Georgia Department of Transportation  
District 7

MSL-0004-00(427), MSL-0004-00(428), and NHS-0001-00(917)  
LEE ROAD/SWEETWATER ROAD WIDENING - PHASE 1, CR 817  
LEE ROAD WIDENING - PHASE 2  
I-20/LEE ROAD INTERCHANGE RECONSTRUCTION  
P. I. Nos. 0004427, 0004428, and 0001917  
Douglas County, Georgia

## Value Engineering Study Report Preliminary Design Phase

January 2007

ALTERNATIVE NO. IR-1 ORIGINAL DESIGN SHEET 2 OF 6

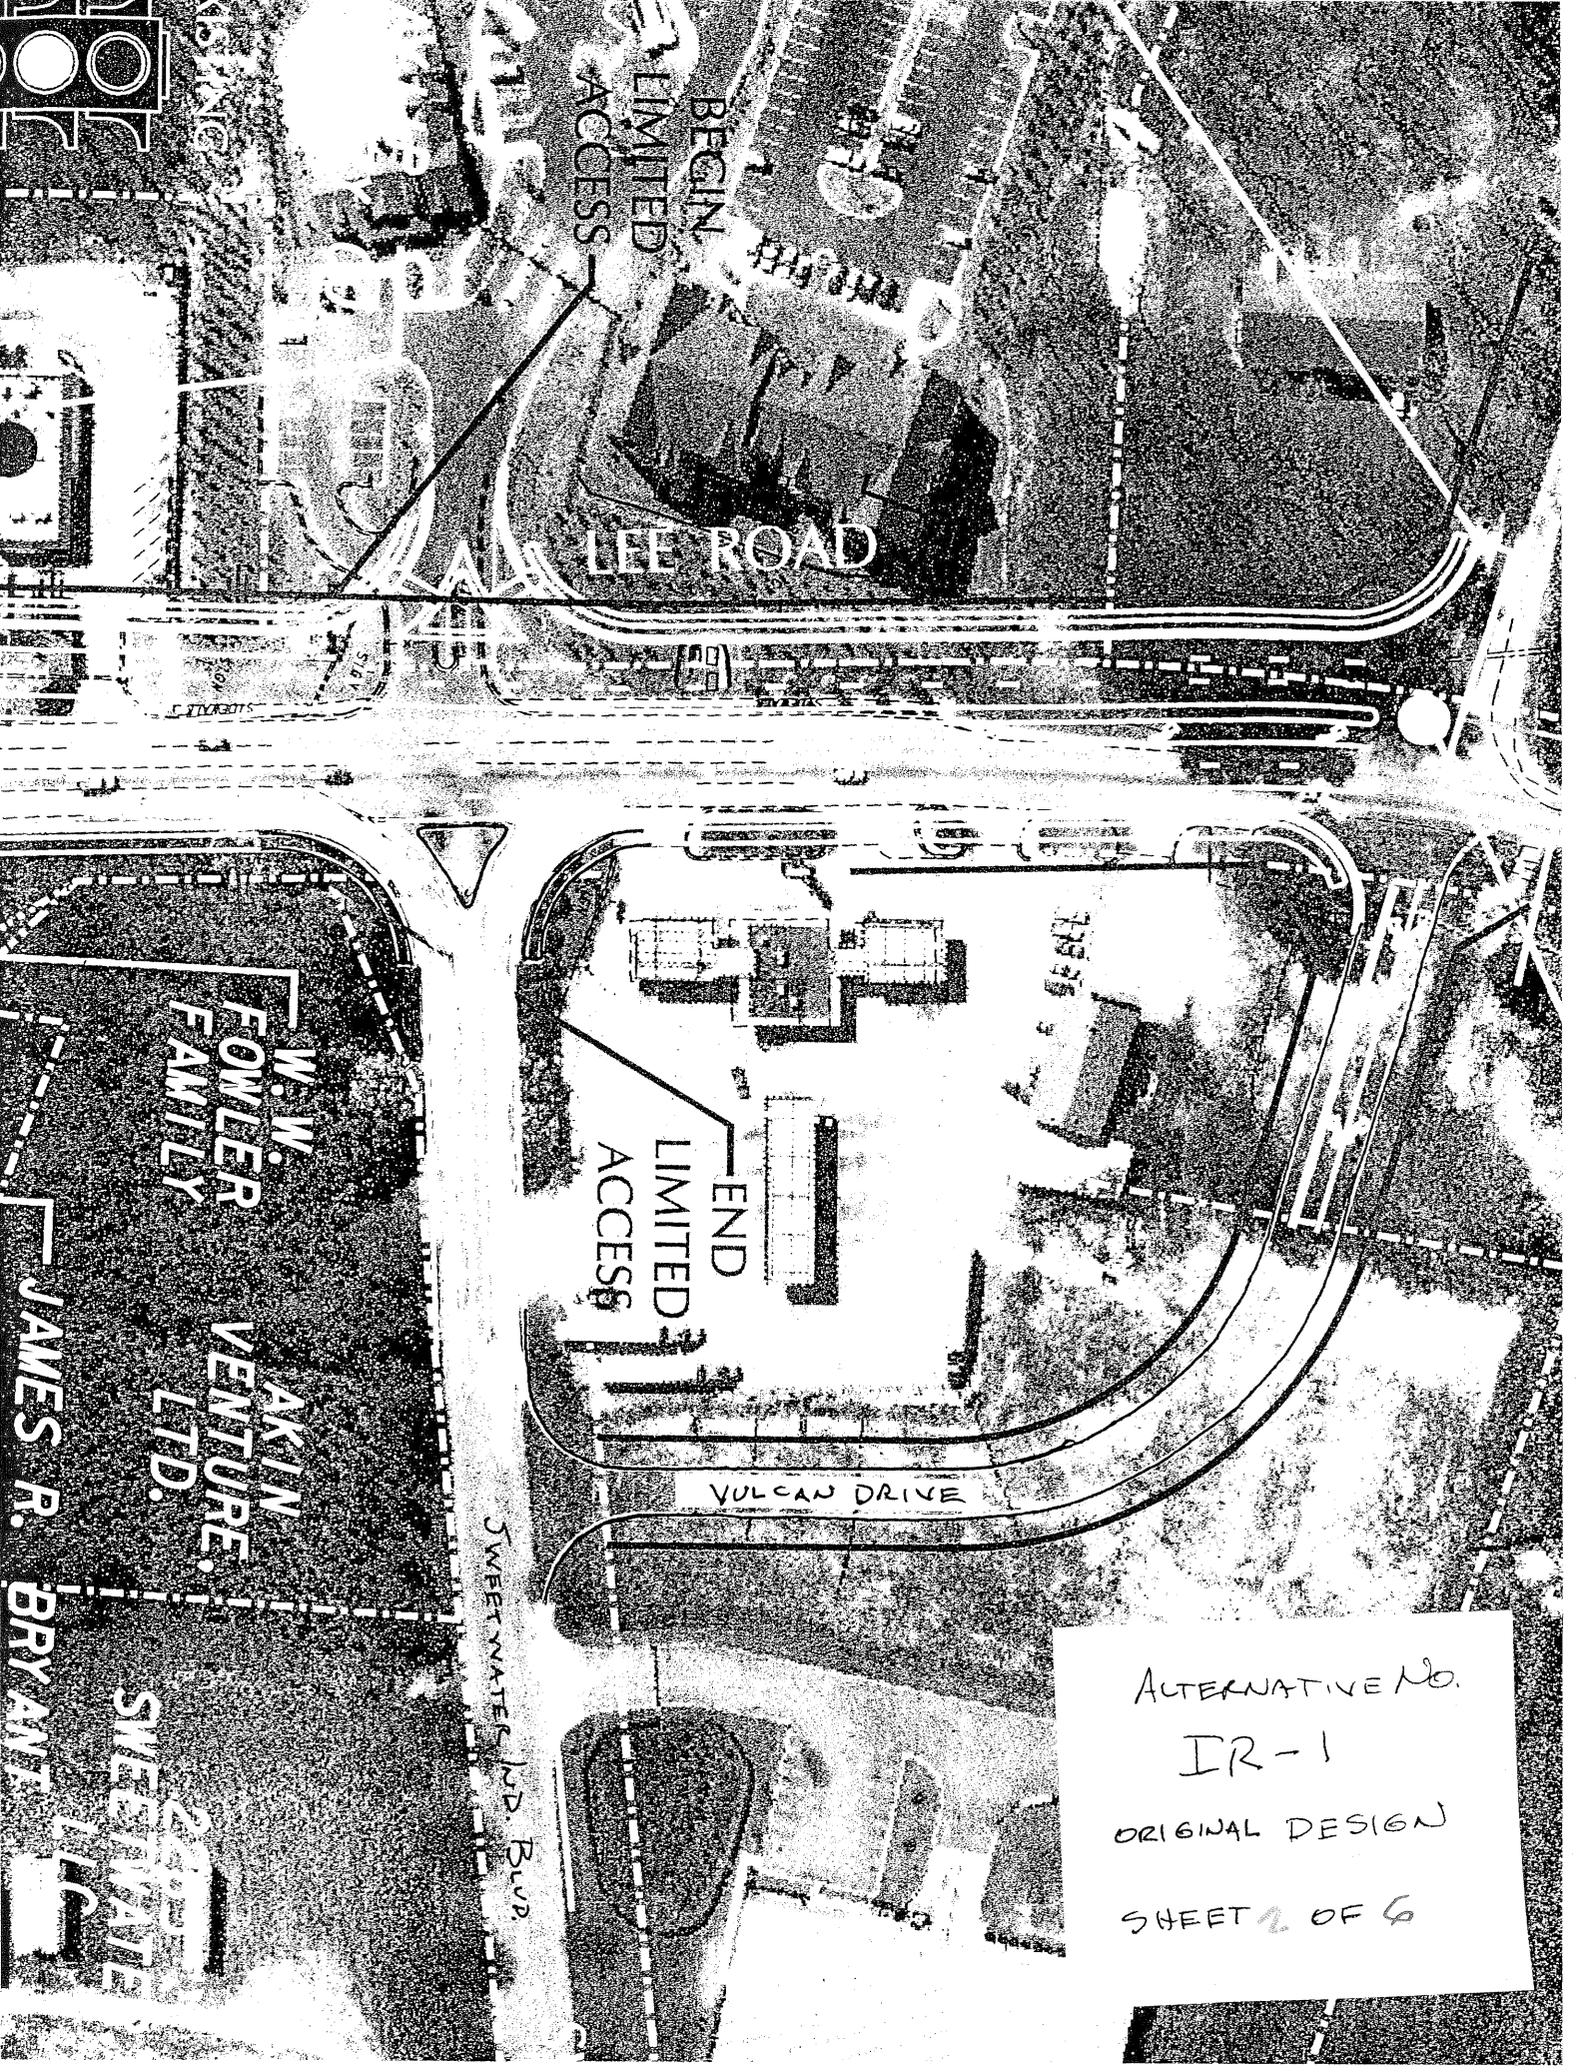
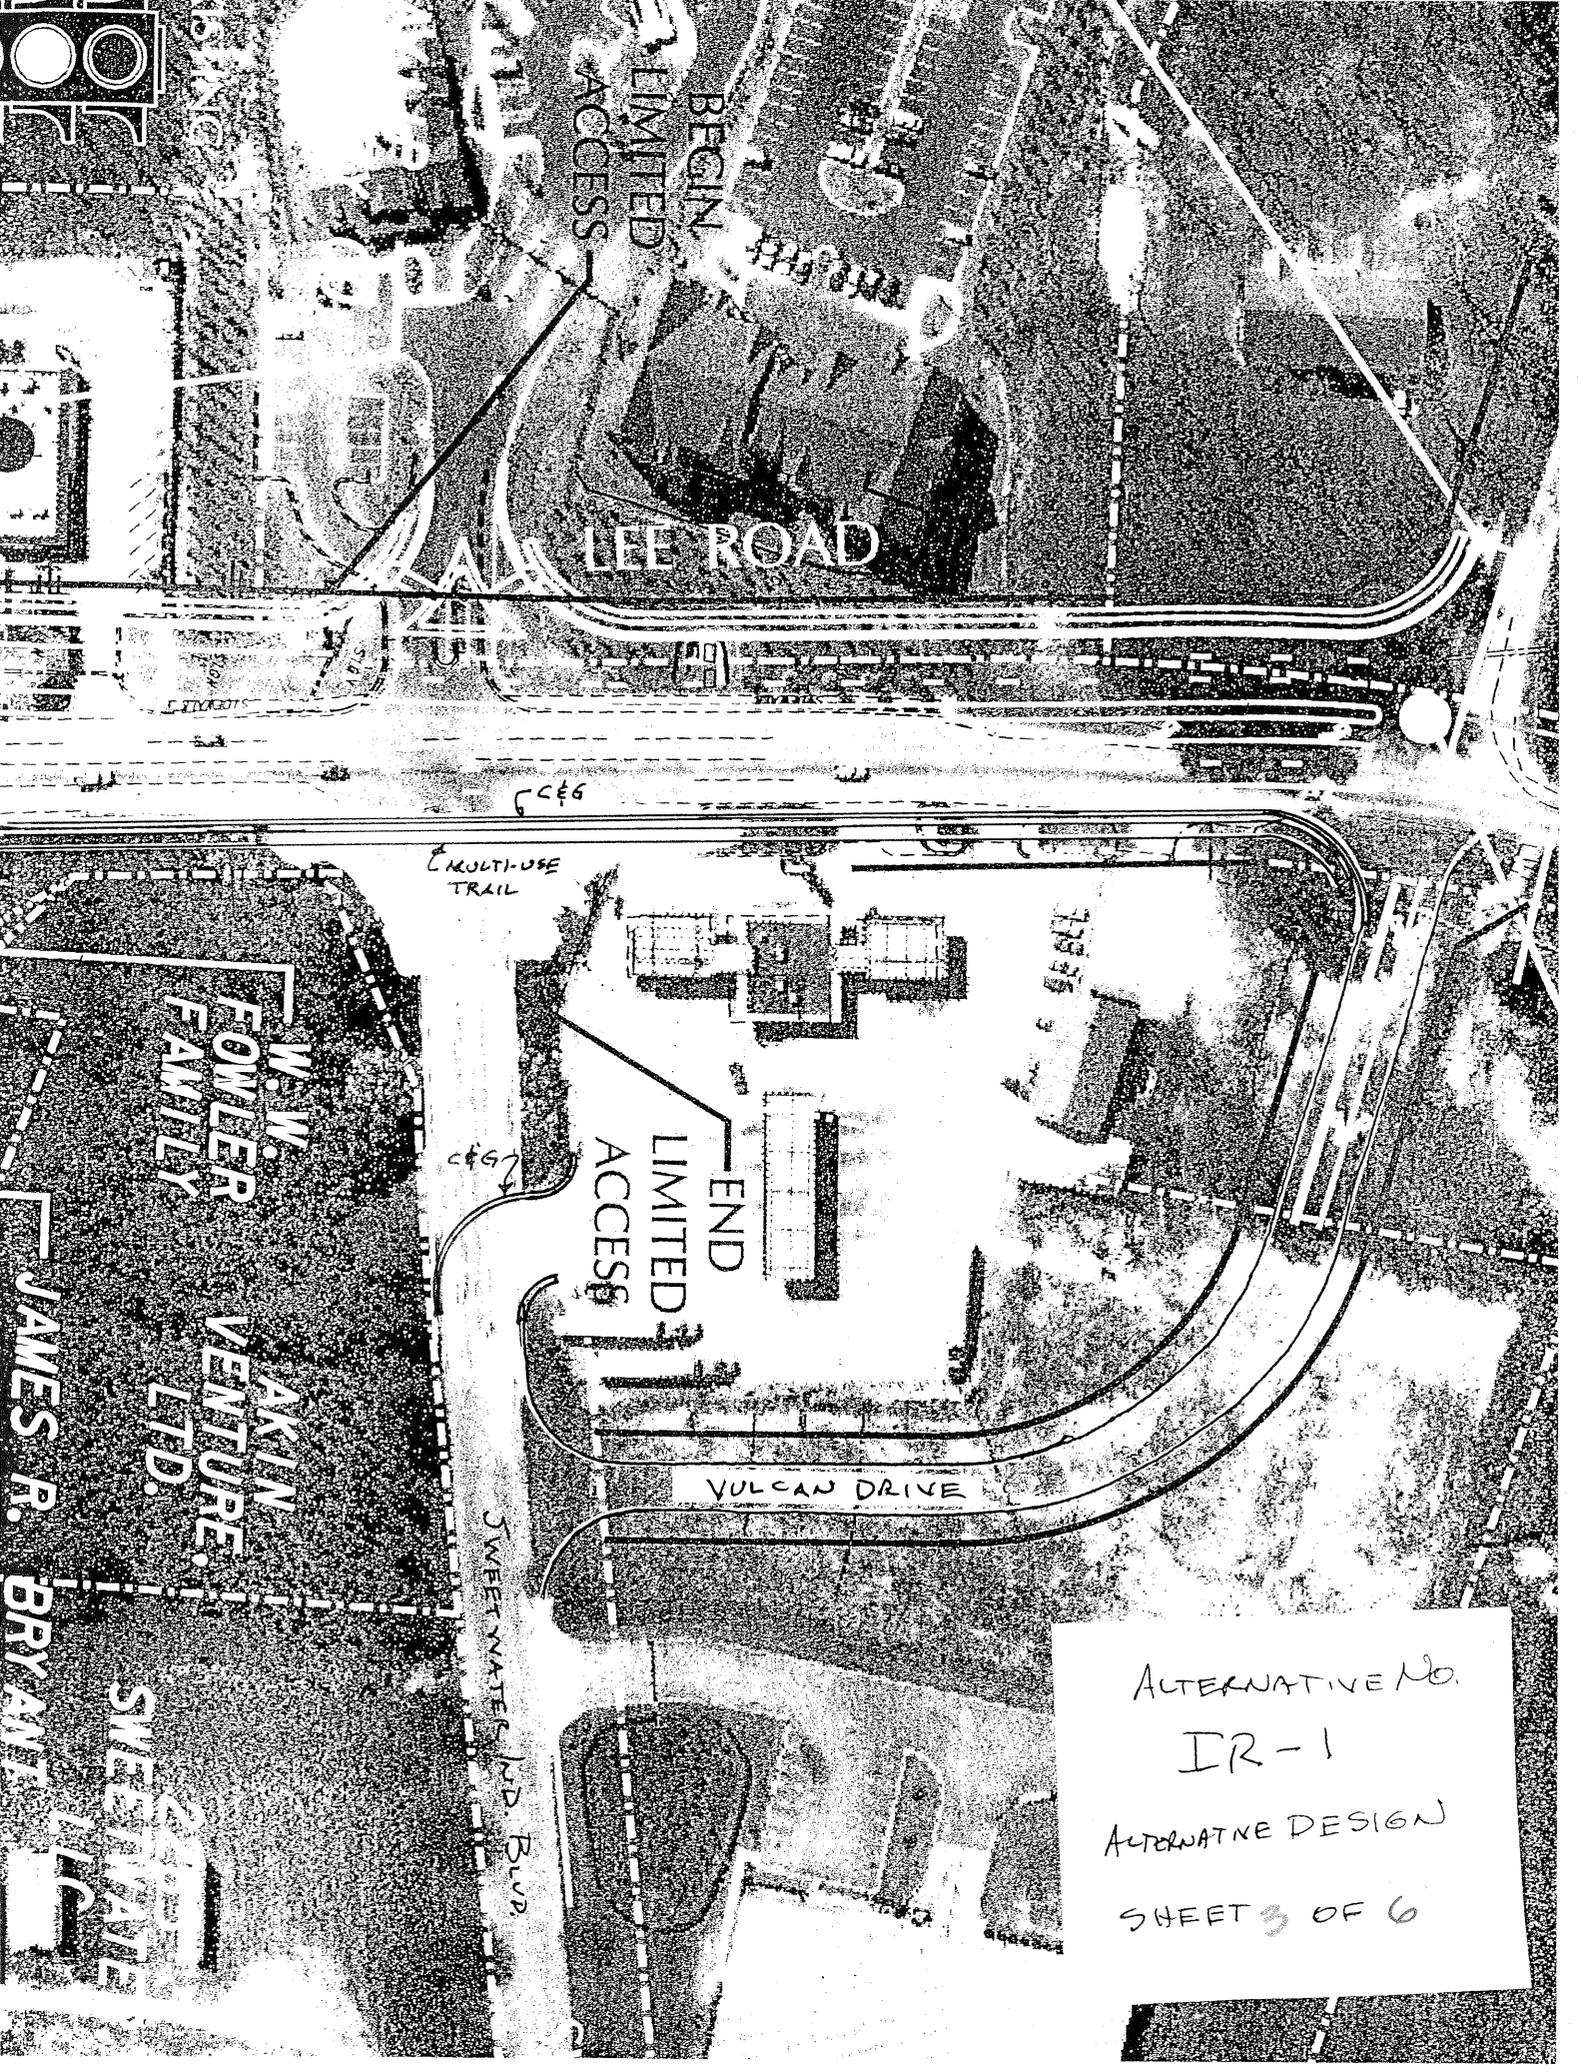
- Eliminates side-by-side intersections on Lee Road
- Improves safety
- Improves traffic flow
- Maintains business access to gasoline station

- Slight increases travel distance to reach Lee Road and I-20

DESCRIPTION: **PROVIDE ACCESS TO BRODICK HILL APARTMENTS FROM  
 VULCAN DRIVE**

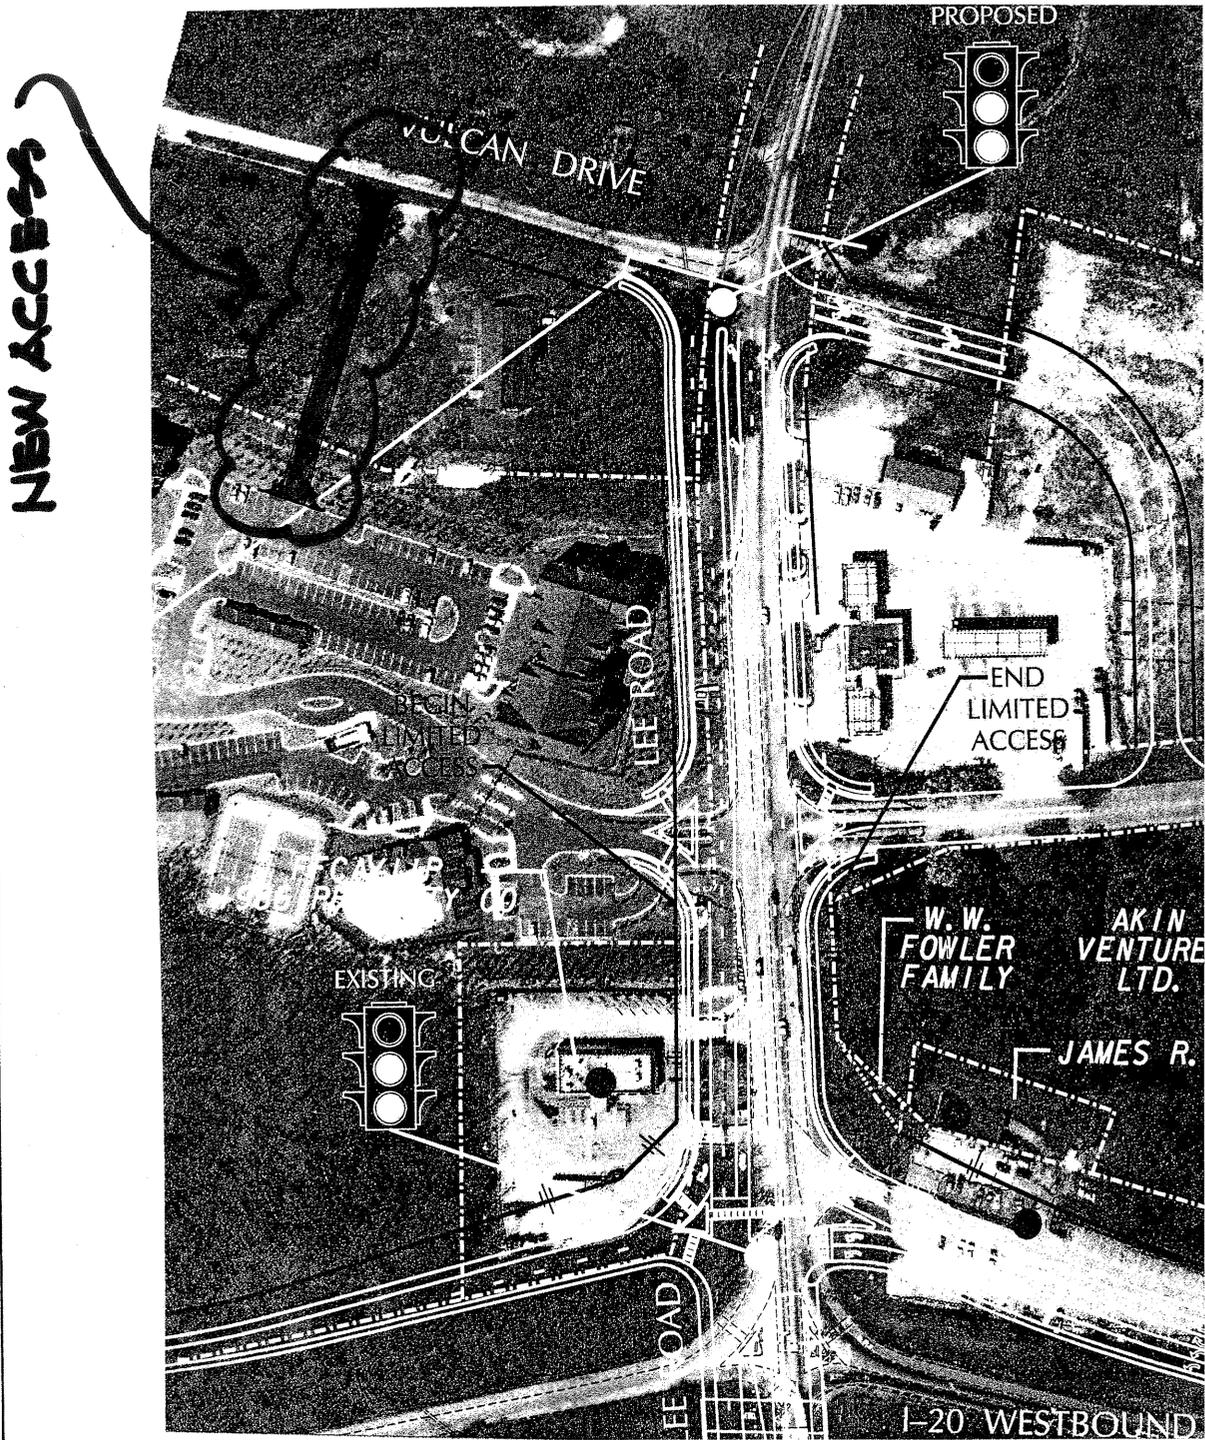
Provide access from the Brodick Hill Apartments onto Vulcan Drive to access Lee Road and Sweetwater Industrial Boulevard.
